Architect's Field Report

15094 Community Bank Headquarters / Report Number 031

Observations Meeting on site to review overhead issues, we walked to review architectural surfaces at the ceiling as well as with Scott woods to review overhead mechanical issues. Attached to this document are observation reports associated with our findings.

Observation Corrective Action #154: Missing or incomplete bolt install at aluminum frames

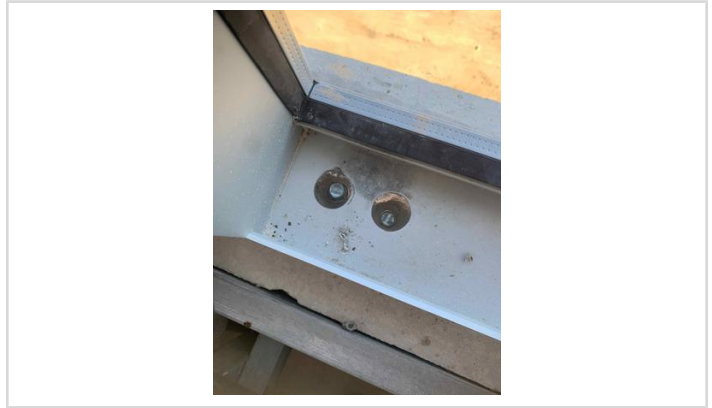
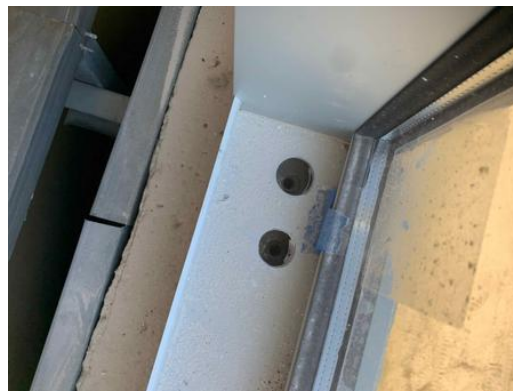
Description Missing screws or screws not fully set

Observation Misc Issues #153: HVAC maintenance issue for filter

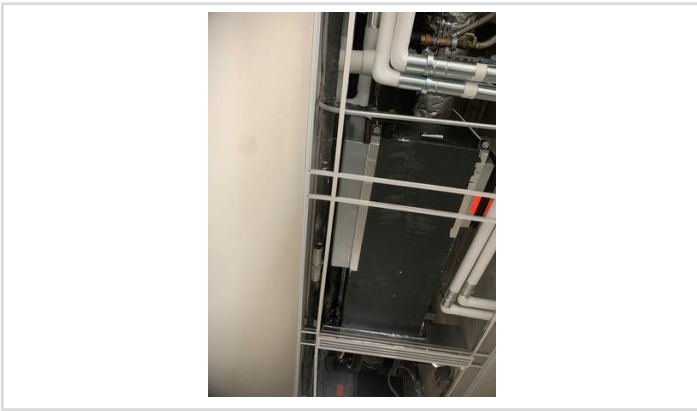
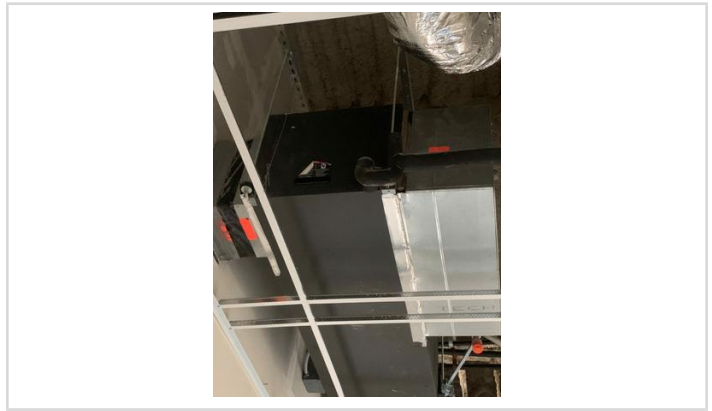
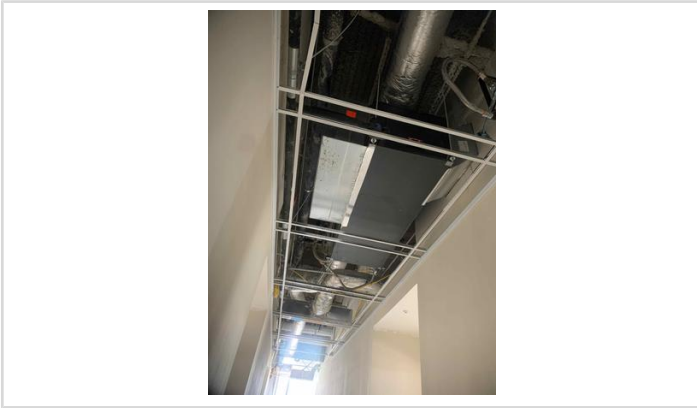
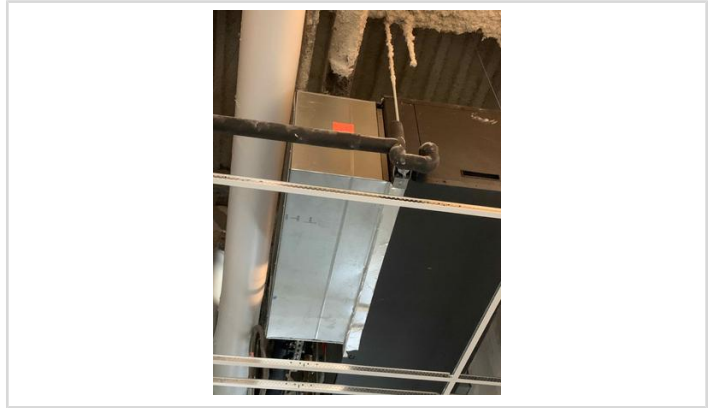
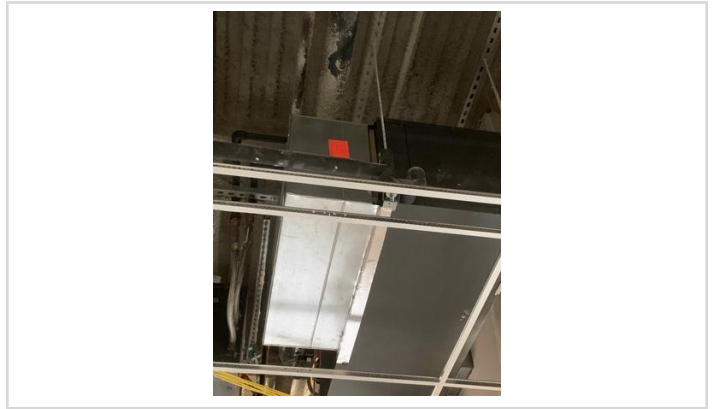
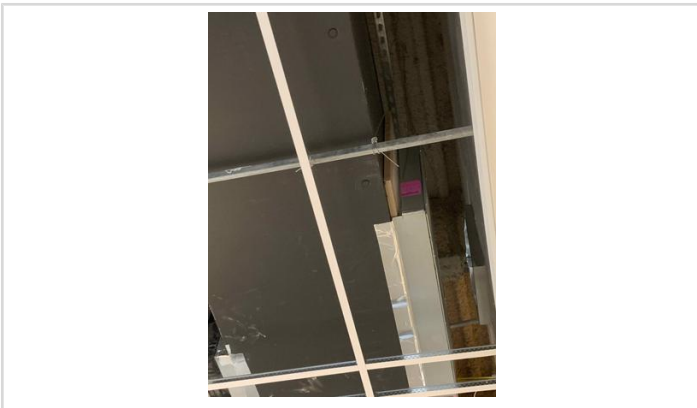
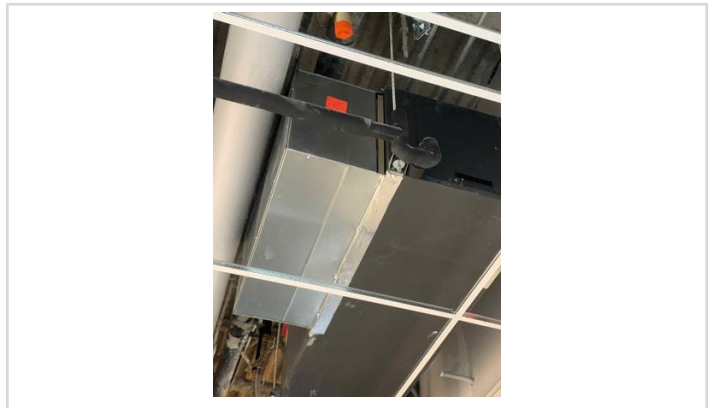
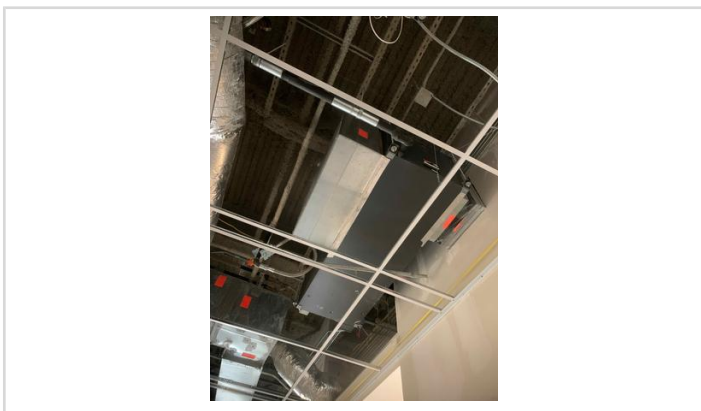
Origin		Status	Initiated
Created By	Paul Purser (Dale Partners Architects, P.A.)	Date Created	Dec 2, 2021
Assignee		Distribution	
Notification Date		Priority	
Location	Interior>Level 4	Trade	MECHANICAL
Due Date	Dec 9, 2021	Private	No
Contributing Condition		Contributing Behavior	
Hazard			
Linked Drawings			
Spec Section			
Description	Unable to change filter without damaging new due to drain placement		
Attachments
